Planning Decisions Committee

6.30pm, Tuesday 28 May 2024

1. This report provides Council with an assessment of the Section 72 Amendment planning permit application PLN21/0670.02 submitted for Nos. 223 - 229 Johnston Street & 369 Gore Street Fitzroy. This amendment application seeks to allow for the additional demolition and reconstruction of sections of the existing Gore Street façade (previously approved to be retained).

Ward: Nicholls
Proposal: Section 72 Amendment to Planning Permit PLN21/0670 to allow for additional demolition and reconstruction of sections of the existing Gore Street façade (previously retained)
Existing use: Vacant commercial buildings
Applicant: Pace Development Group Pty Ltd
Zoning / Overlays: Commercial 1 Zone (C1Z)
 Abutting Transport Zone - Category 2 (TRZ2)
 Design and Development Overlay - Schedules 10 and 36 (DDO10 & DDO36)
 Development Contribution Plan Overlay - Schedule 1 (DCPO1)
 Environmental Audit Overlay (EAO)
 Heritage Overlay – Schedule 334 (HO334)
Date of Application: 21 November 2023
Application Number: PLN21/0670.02

Figure 3: Extent of approved demolition (top image) and proposed additional demolition (bottom image) Source: SJB (top image: January 2023, bottom image: August 2023)

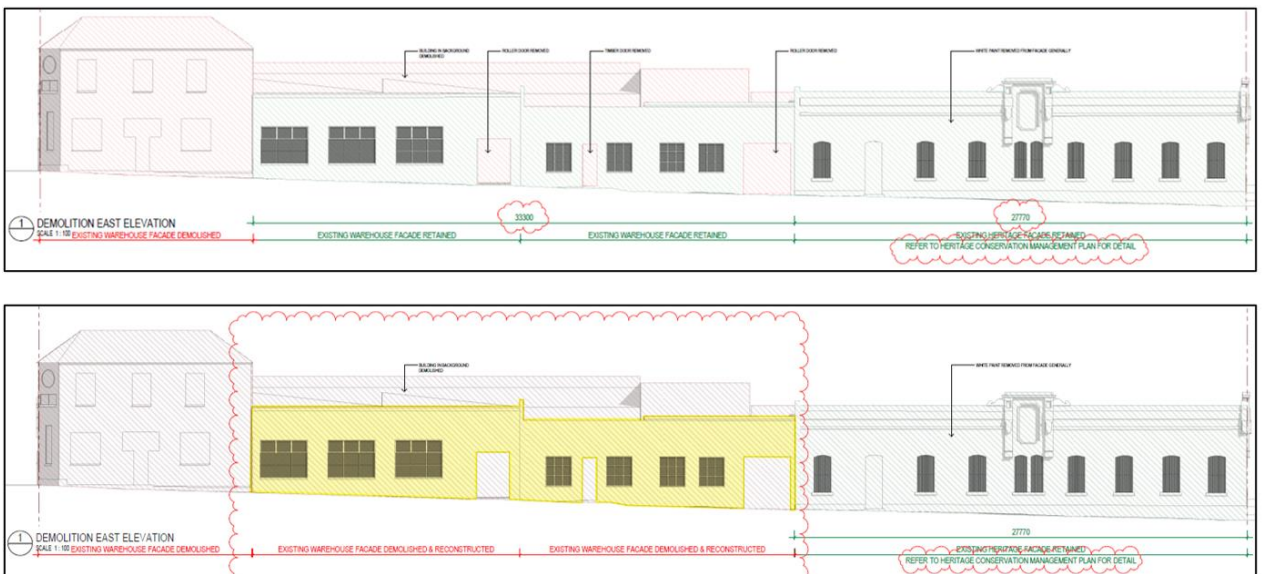
16. Figure 3 below shows a comparison between the extent of approved demolition and proposed additional demolition (highlighted in yellow) of the Gore Street façade.

50. Policy at *Clause 15.03-1S* (Heritage conservation), *Clause 15.03-1L* (Heritage) and *Clause 43.01* (Heritage overlay) of the Scheme provide guidance in considering the extent of demolition and reconstruction. As shown in Figure 3 earlier in the report, the proposal results in additional demolition and reconstruction of two sections of the Gore Street façade. These two sections were previously proposed to be retained.

Figure 8: Discrepancy of the high-level window Source: IGS (October 2023)

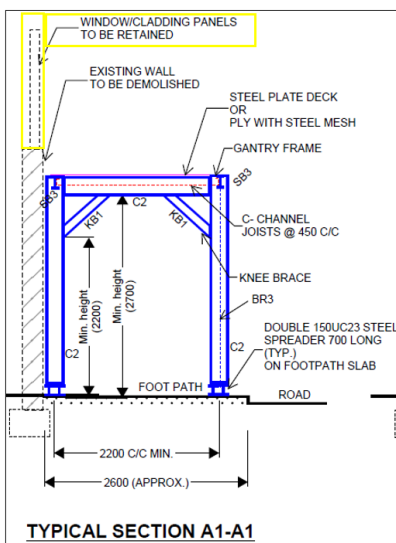
- 60. PSP were generally supportive of the structural engineer reports outlining that further structural assessment documented and certified by a suitably qualified structural engineer should be supplied to Council during the Building Permit stage. This is a separate stage from the planning process.
- 61. PSP identified a discrepancy between the amended Structural Report, the demolition elevations and the Conservation Management Plan with regard to existing high-level window panelling on the Gore Street façade. Figure 7 below shows this discrepancy highlighted in yellow, where the plans show these windows replaced with brickwork. In contrast, the amended Structural Report (as shown in Figure 8) shows these window/cladding panels to be retained.

63. Given that the window panelling appears to be a later addition with no heritage value (given this was not identified as a concern in the original planning process), the retention of these high-level windows is not required. The provision of brick, as shown in the already endorsed plans is a more appropriate outcome from a heritage perspective. Therefore, it is not required to amend the Structural Report. No further changes is required to Condition 9 (Structural report).

Figure 9: Endorsed east elevation with the relevant section of wall outlined in yellow.
Source: SJB (November 2023)

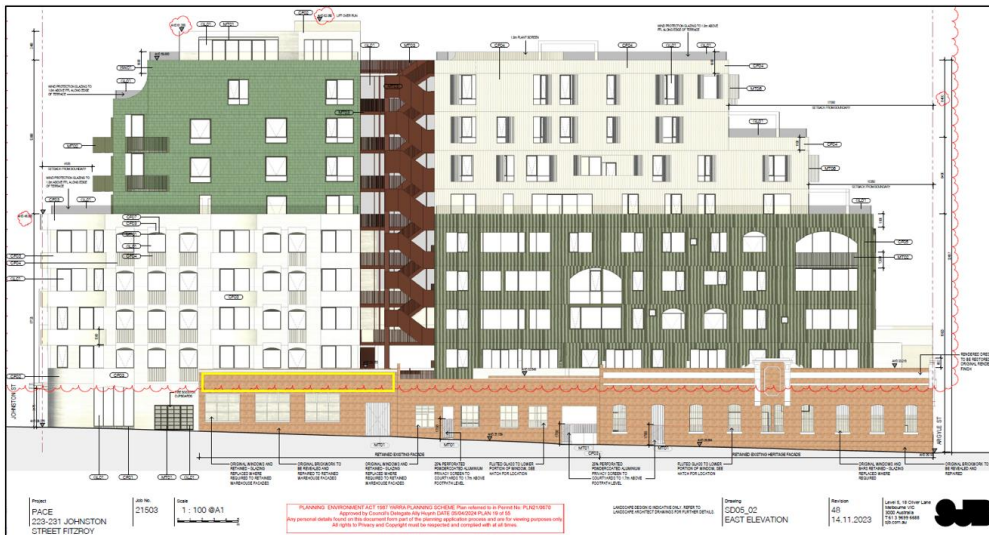
- 62. The approved works show this section of the façade to consist of brickwork instead of window panelling. See Figure 9 below which shows the endorsed east elevation.

Figure 1: The section of wall that is sought to be demolished and reconstructed in the present amendment to the approval is coloured yellow.

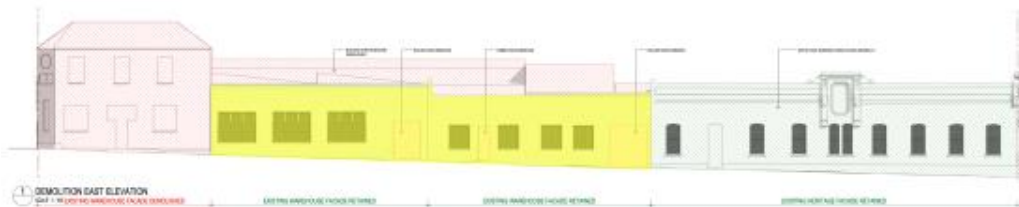
The Heritage Impact Statement submitted with the original application for the development of the site concluded that the walls shaded yellow above “did not contribute to the same degree as the former Argyle shirt factory and are considered secondary in character and interest”. Despite this finding it was considered that the subject walls contribute to the industrial character of the site as it presents to Gore Street.

Figure 1 – Proposed amendment to façade (excerpt from Drawing SD05_05 (Rev 47) – Demolition Elevations, prepared by SJB)

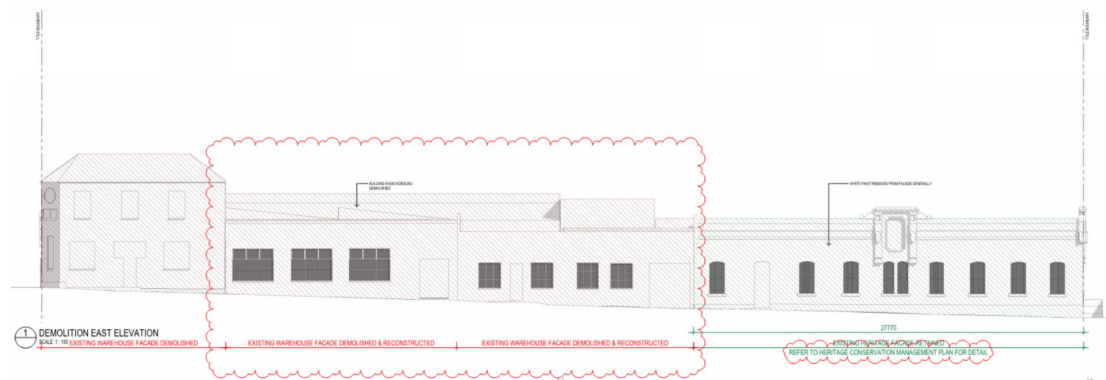
PSP understands that the Developer has proposed an amendment to the planning permit (PLN21/0670) in relation to the treatment of the existing façade to the south of Gore Street. An excerpt of this elevation is indicated in Figure 1 below, with the façade subject to this amendment clouded in red. This extent of the façade, indicated to be approximately 33.3m long, is understood to be only of limited heritage value. As such, the Developer is suggesting that it be demolished and reconstructed. PSP understands that no amendments are proposed to the treatment of the existing heritage façade, which is of individually significant heritage value to the north of Gore Street (approximately 27.7m length) and along Argyle Street.

Figure 2 - Photograph from Bryce Raworth CMP

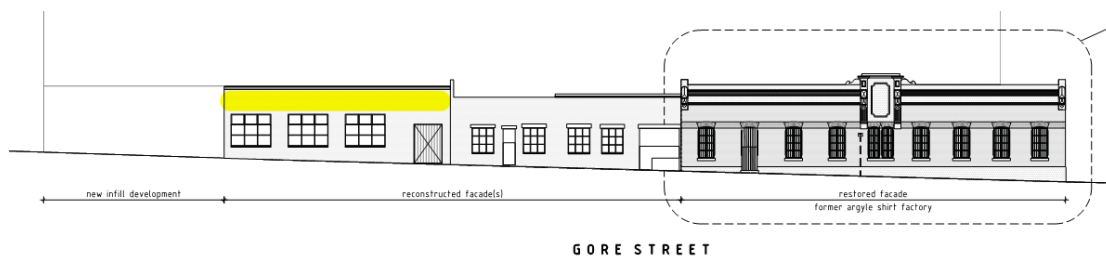
F3. There appears to be some discrepancy regarding the treatment of the high-level window panelling when examining architectural elevations and amending CMP against the ISG structural report documentation. The CMP and architectural elevations appear to have excluded these panel elements from the reconstructed façade and replaced them with masonry. However, 'Typical Section A1-A1' in 'Job No. 19177, Drawing No. S002 (Rev 1)' of the ISG Structural Report indicates that these window/cladding panels will be retained. The need to clarify the treatment of this component was highlighted in findings and recommendations 'F3' and 'R3' in the letter 23-S-012-LET-001 (Rev 0), previously issued by this office. Figure 2 below depicts the current appearance of the panels, while Figure 3 indicates the proposed reconstruction as per the amended CMP. Refer Recommendation 'R3'.

R3. Council should confirm whether it is satisfied with the extent of masonry walling shown on Gore Street, with particular reference to the extent highlighted in Figure 3. If the wall type is to be changed, the lintels may need to be upsized to support the heavier masonry. Additional brickwork would also be required as part of reconstruction works to infill this portion of the façade. Should Council wish for this portion of walling to be retained as cladding or sheet panelling as historically the case, it may advise the architect to revise its elevations to Council's satisfaction. Regardless of the treatment of this portion of the façade, verifying the condition and suitability of the existing loadbearing lintels or header members over openings to support the required loads will be necessary. The existing lintels are noted to have some cracking, as per the ISG Condition Report. Council may wish to request a structural assessment or structurally certified design submission on load-bearing elements of the façade brickwork.
